AGENDA

Committee	PWYLLGOR CYNLLUNIO
Date and Time of Meeting	DYDD MERCHER, 23 IONAWR 2019, 1.30 PM
Venue	YSTAFELL BWYLLGORA 4 - NEUADD Y SIR
Membership	Councillor Keith Jones (Cadeirydd) Councillors Lay, Ahmed, Asghar Ali, Congreve, Driscoll, Gordon, Hudson, Jacobsen, Jones-Pritchard a/ac Sattar

PLANNING COMMITTEE

Title
Proposed Elevations, Roof & Site location
Plan

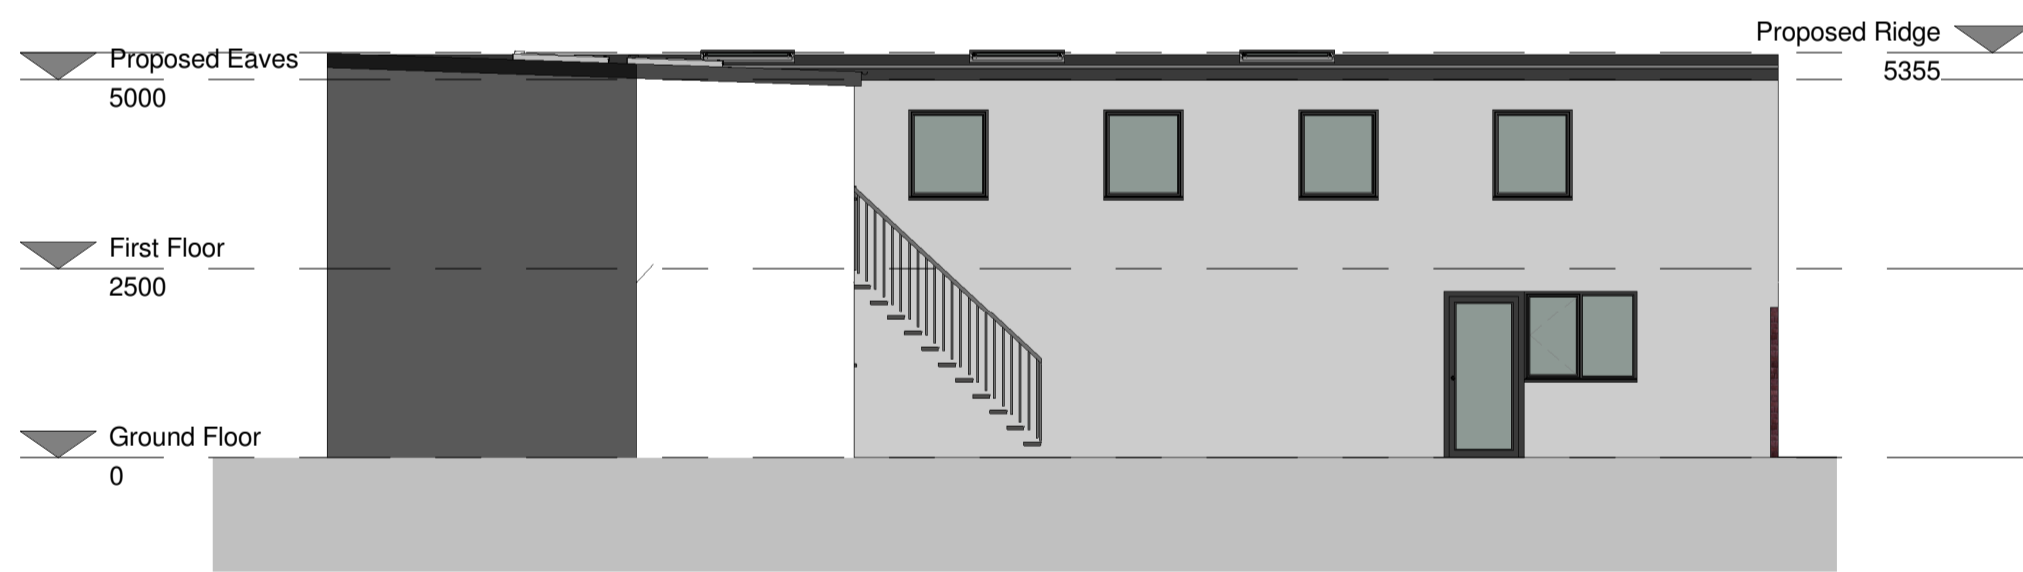
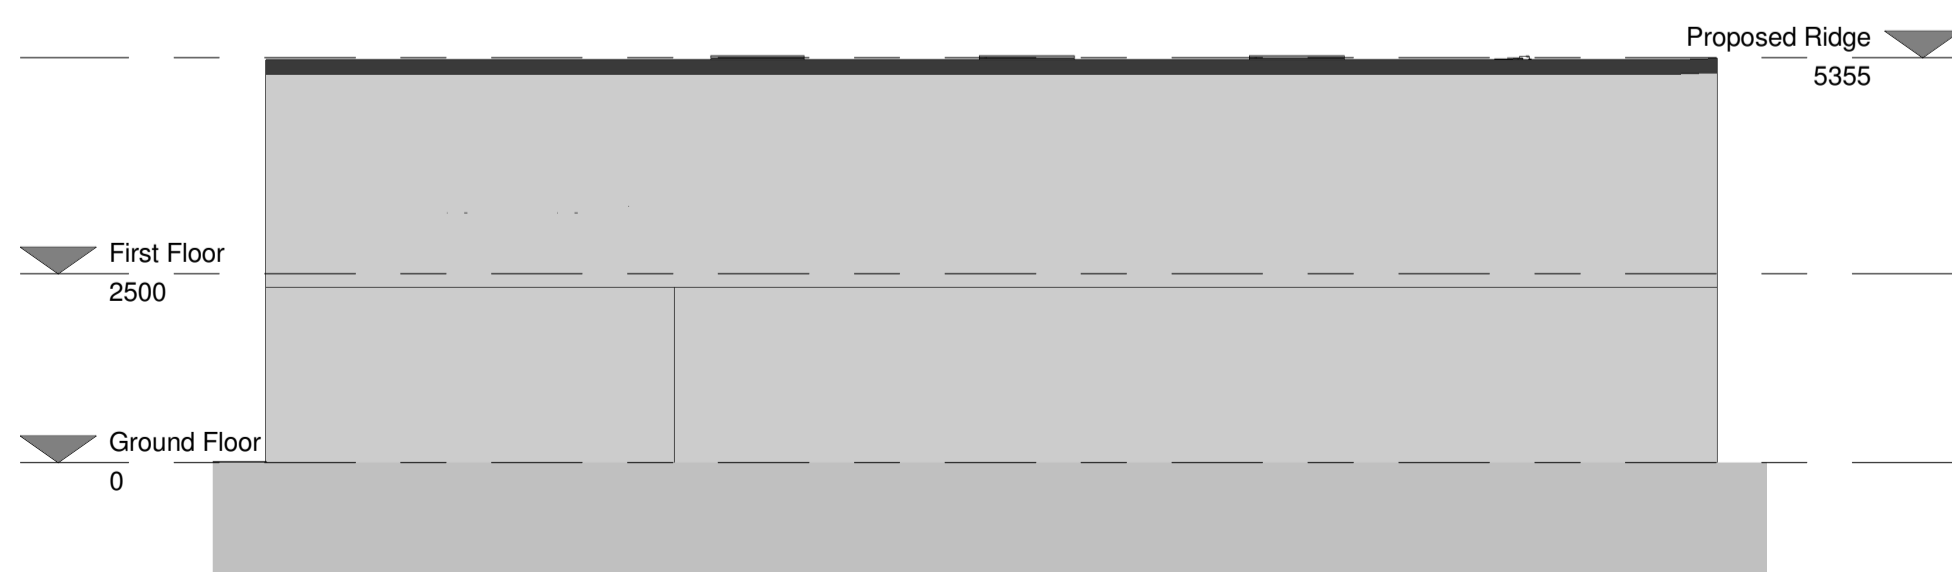
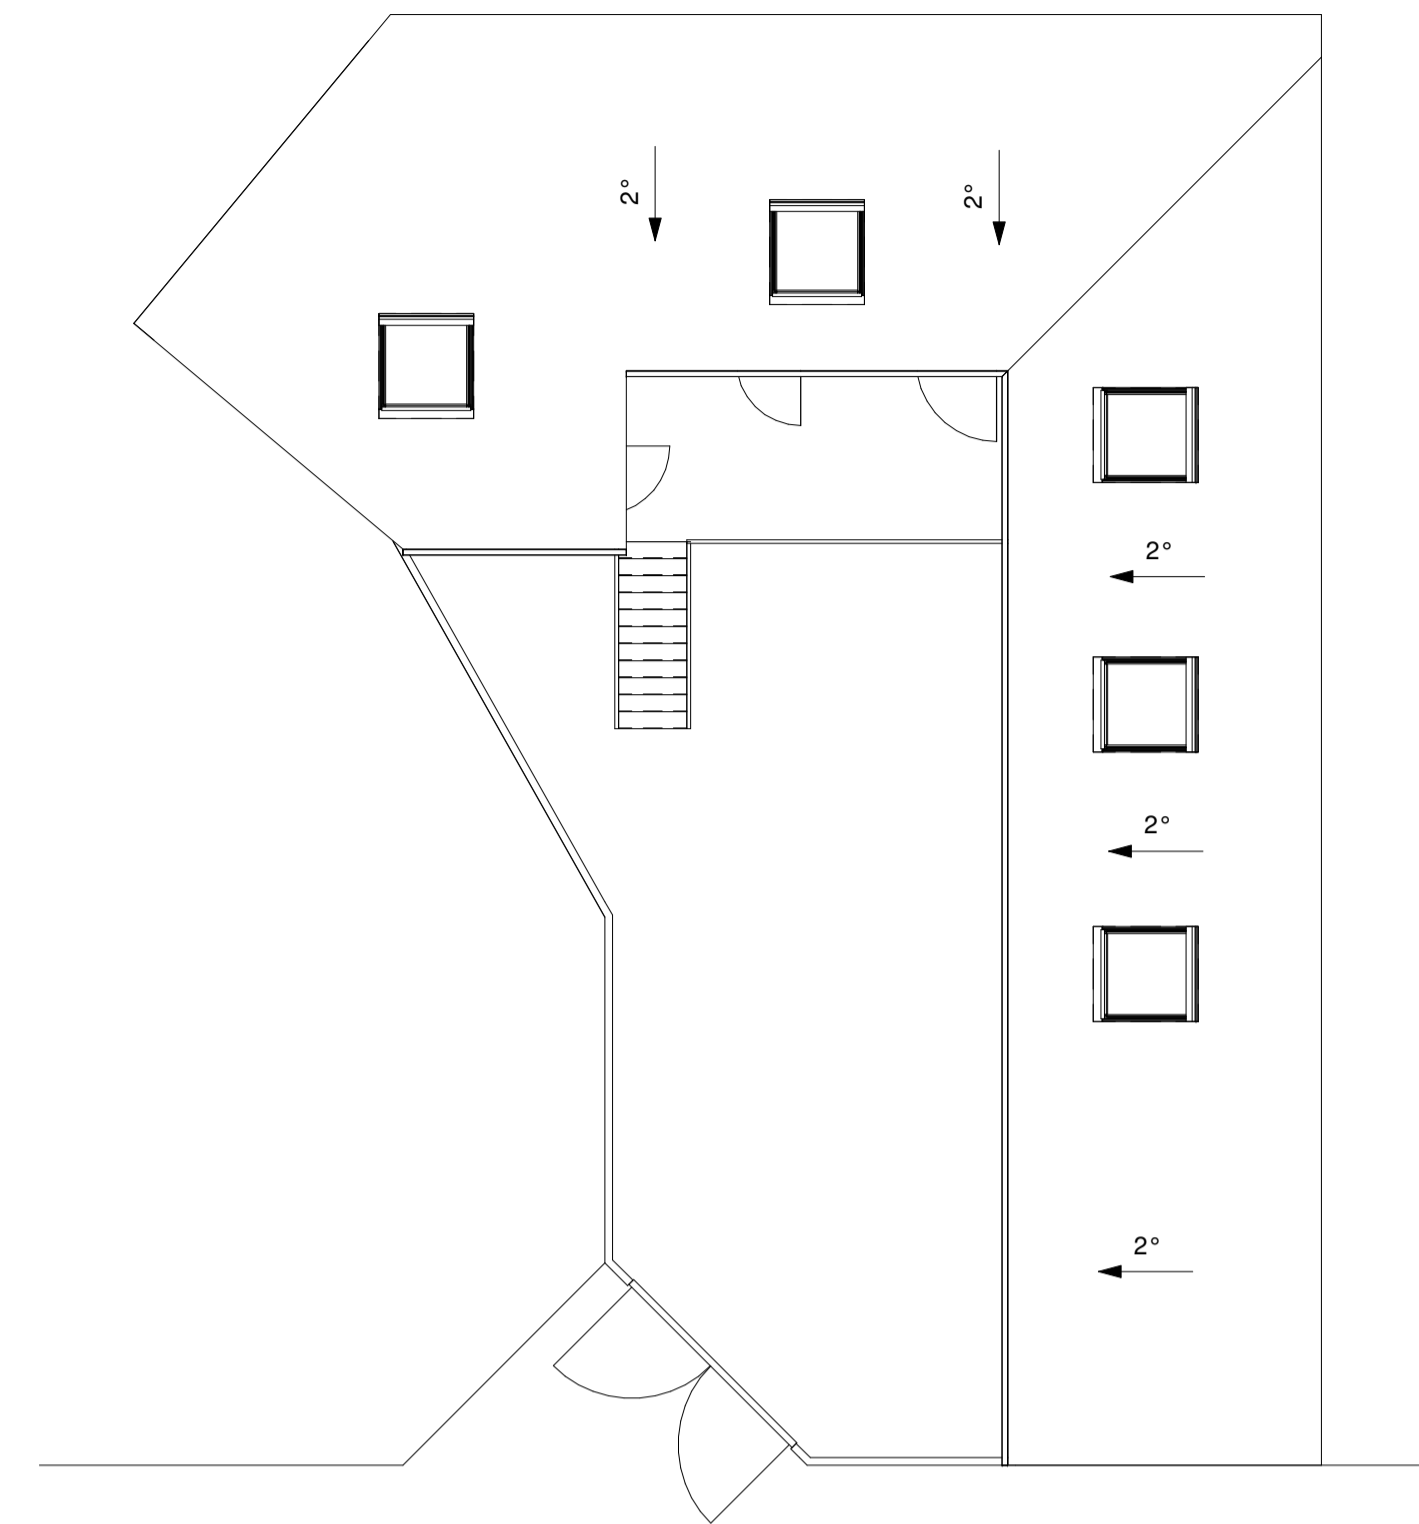
8.3 It is considered that due to the height, length, scale and massing of the proposed extensions it would have an overbearing and unneighbourly impact upon the amenities of the adjoining neighbours and be contrary to Policy KP5 of the Cardiff Local Development Plan (2006-2026).
